Peer Review of Highlands Neighborhood Traffic and Pedestrian Safety Plan

DRAFT REPORT

Prepared for:
Ada County Highway District

Prepared by:
SIX MILE ENGINEERING, PA

Figure 1-2. Traffic diverter at the intersection of Braemere Road and Curling Drive

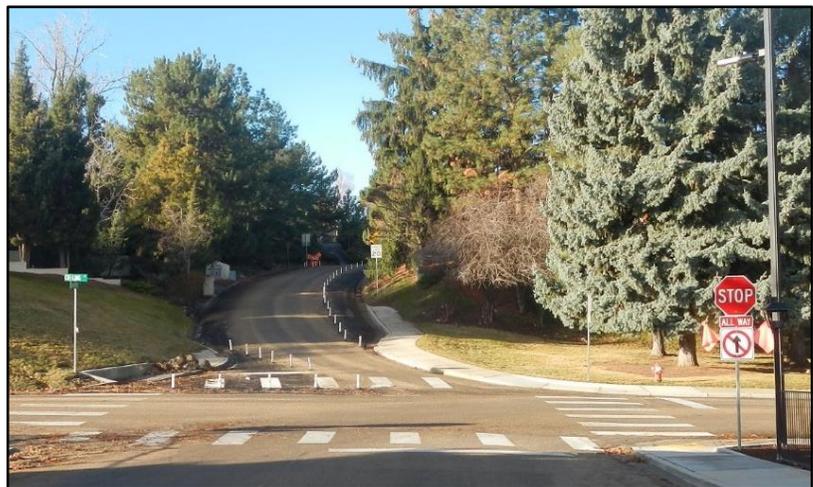
- The diverter at the intersection of Braemere Road and Curling Drive worked as intended, reducing cut-through traffic on Lower Braemere Road by approximately 930 vpd, from 1,350 to 420 vpd, a reduction of nearly 70 percent.

The diverter worked as intended, reducing cut-through traffic on Lower Braemere Road by approximately 930 vpd, from 1,350 to 420 vpd, a reduction of nearly 70 percent. Traffic was also reduced by a similar amount on Highland View Drive, from Lower Braemere Road to Parkhill Drive.

In our view, the diverter has improved safety for pedestrians on Lower Braemere Road by reducing overall traffic volumes to levels that are more appropriate for the roadway's functional classification. By re-routing most of the cut-through traffic on Lower Braemere Road to Curling Drive, traffic from the upper Highlands neighborhood are driving the neighborhood's roadways using the correct roadway hierarchy progression. Traffic is driving from local streets to collector streets (Upper Braemere Road and Curling Drive) to arterial streets (Bogus Basin Road), instead of using a local street (Lower Braemere Road) to traverse from collector to collector.

Figure 2-5. Estimated cut-through traffic on Lower Braemere Road before mitigation

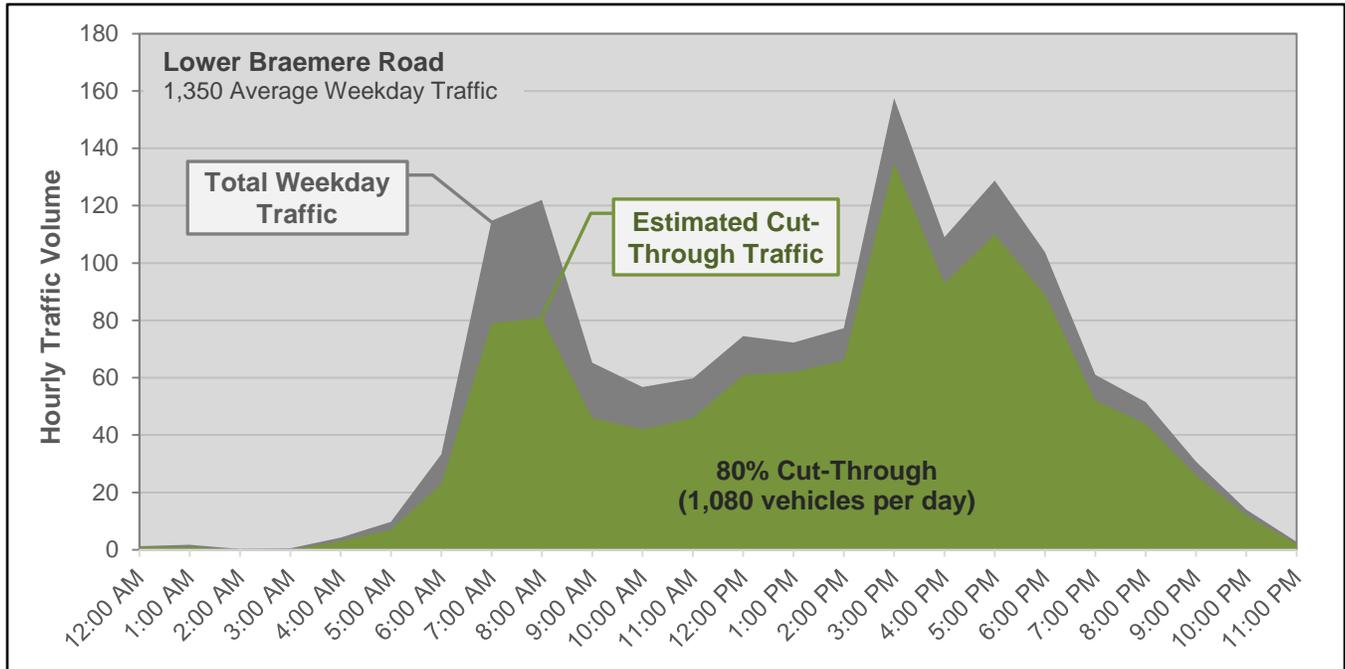
On Lower Braemere Road, the estimated cut-through traffic is shown in Figure 2-5 on page 13. During the average weekday, traffic on Lower Braemere Road was counted at approximately 1,350 vpd. At the count location, approximately, 270 vpd are estimated to be non-cut-through trips, resulting in the estimated cut-through traffic of approximately 1,080 vpd, or 80 percent of the daily traffic.

Figure 3-1. Cut-through traffic mitigation measures developed by ACHD

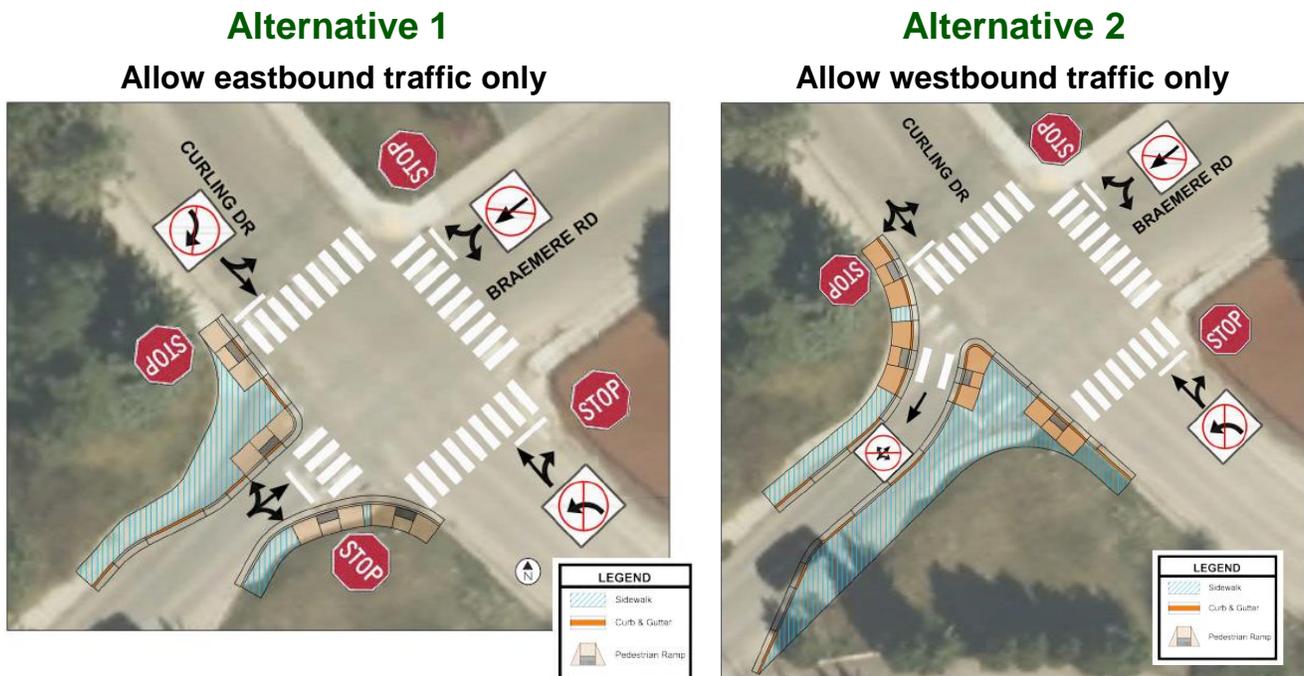
Both of the ACHD alternatives eliminate one direction of travel on Lower Braemere Road at the Curling Drive intersection. Alternative 1 would have a smaller impact on altering neighborhood circulation, but would not reduce as much cut-through traffic as Alternative 2. Alternative 1 restricts westbound cut-through traffic but does not prohibit eastbound cut-through traffic, potentially reducing cut-through traffic by 45 to 50 percent, which equates to a 35 to 40 percent reduction in total traffic on Lower Braemere Road. Alternative 2 restricts eastbound traffic but allows westbound right-turns from Curling Drive to Lower Braemere Road, potentially reducing cut-through traffic by 85 to 90 percent, which equates to a 70 to 75 percent reduction in total traffic.

Completely eliminating cut-through traffic on Lower Braemere Road would require closing vehicle access to Lower Braemere Road from Curling Drive but would cut off important connectivity between the lower Highlands neighborhood and Highlands Elementary. Alternative 2 still allows one-way connectivity to Highlands Elementary and would reduce the highest volume of cut-through traffic. This alternative also encourages a better drop-off and pick-up pattern on the school side of Curling Drive, than Alternative 1. Alternative 1 encourages a drop-off and pick-up pattern on the opposite side of the school on Curling Drive, forcing school children to cross Curling Drive. Alternative 1 would also not reduce total traffic on Lower Braemere Road below 100 vehicles in the PM peak hour, which is one of ACHD's threshold requirements for cut-through traffic mitigation. Alternative 2 was the better of the two alternatives when considering cut-through traffic reduction and school circulation.

Figure 3-4. Average weekday volumes – before, after, difference and percent difference

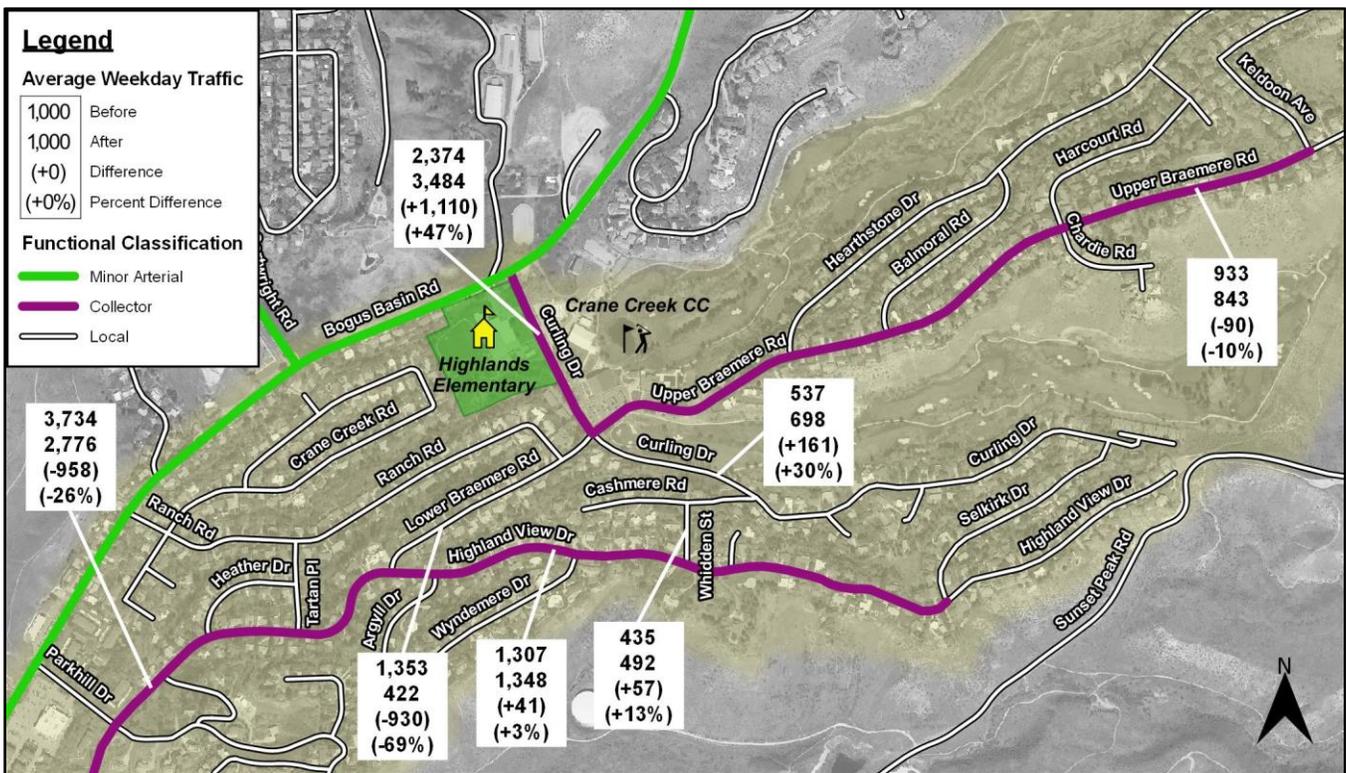
After Highlands neighborhood residents and visitors had several months to learn their new route through the neighborhood, traffic volumes were collected and compared to the before volumes to evaluate the traffic re-distribution patterns (Figure 3-3). As expected, the diverter has reduced the majority of cut-through traffic on Lower Braemere Road by approximately 930 vpd.

The majority of the 930 vehicles per day re-routed from Lower Braemere Road now travels on the collector segment of Curling Drive between Upper Braemere Road and Bogus Basin Road. On this segment of Curling Drive, the before and after counts were not collected at the same location. Before counts were obtained near Crane Creek parking lot and after counts were approximately 500 feet north near the school pedestrian crossing. As a result, the increase in traffic volume on Curling Drive may be overestimated because the before count may be low by potentially not capturing some school drop-off and pick-up traffic originating and returning to locations outside the Highlands neighborhood.

Traffic was reduced on Highland View Drive between Lower Braemere Road and Parkhill Drive by approximately the same amount as the traffic reduction on Lower Braemere Road. Small increases in re-routed traffic occurred on other local streets such as Whidden Street and Ranch Road, but were less than 60 vehicles per day (maximum of 10 additional vehicles in peak periods).

Figure 3-7. New all-way stop intersections

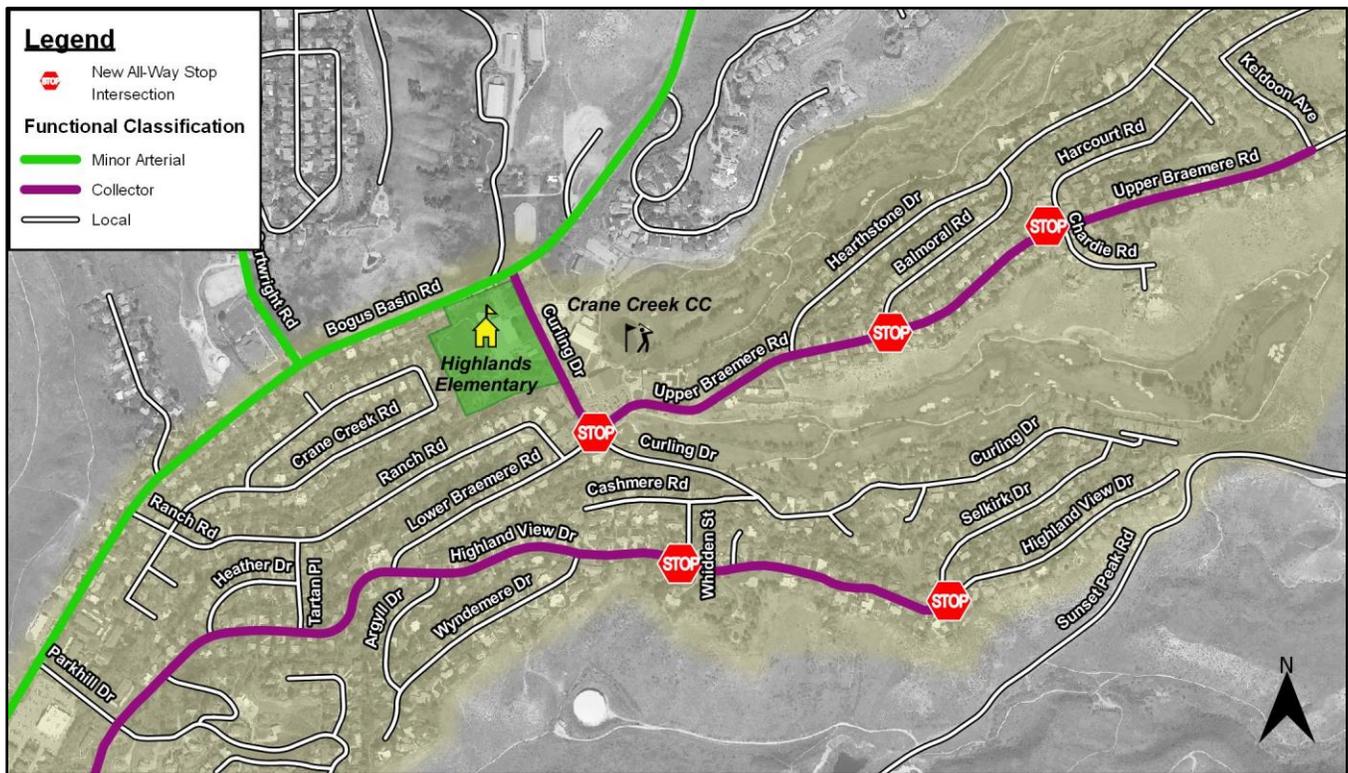
At the four new all-way stop locations on Upper Braemere Road and Highland View Drive, few pedestrians were observed crossing the major roadway during the AM and PM school arrival and release periods. No collector street pedestrian crossings were observed in the AM. In the PM period, two intersections had no crossings, one intersection had two crossings, and one had three crossings.

The all-way stop intersections were rarely used as collector street pedestrian crossings, with the exception of the Curling Drive and Braemere Road intersection.

On **Curling Drive**, the signs should remain as a permanent traffic calming measure. They have helped reduce speeds and provide a needed stop-controlled pedestrian crossing of Curling Drive at Braemere Road.

On **Upper Braemere Road**, the stop signs at the Balmoral Road intersection have helped reduce speeds in the vicinity, but the performance of the stop signs at the Harcourt Road/Chardie Road intersection are unknown. Due to the limited comparison of before and after conditions, we do not have an opinion on whether stop signs on Upper Braemere Road should remain as permanent traffic calming measures. Likewise, we do not have an opinion on whether the stop signs on **Highland View Drive** should remain as permanent traffic calming measures. However, we recommend that the stop signs remain as temporary measures on Upper Braemere Road and Highland View Drive until the majority of the homes in Highlands Cove subdivision are constructed to slow contractor and heavy vehicle traffic in the vicinity of the stop-control intersections. We also recommend installing additional speed limit signs on both roadways to remind visitors and contractors of the maximum speed.
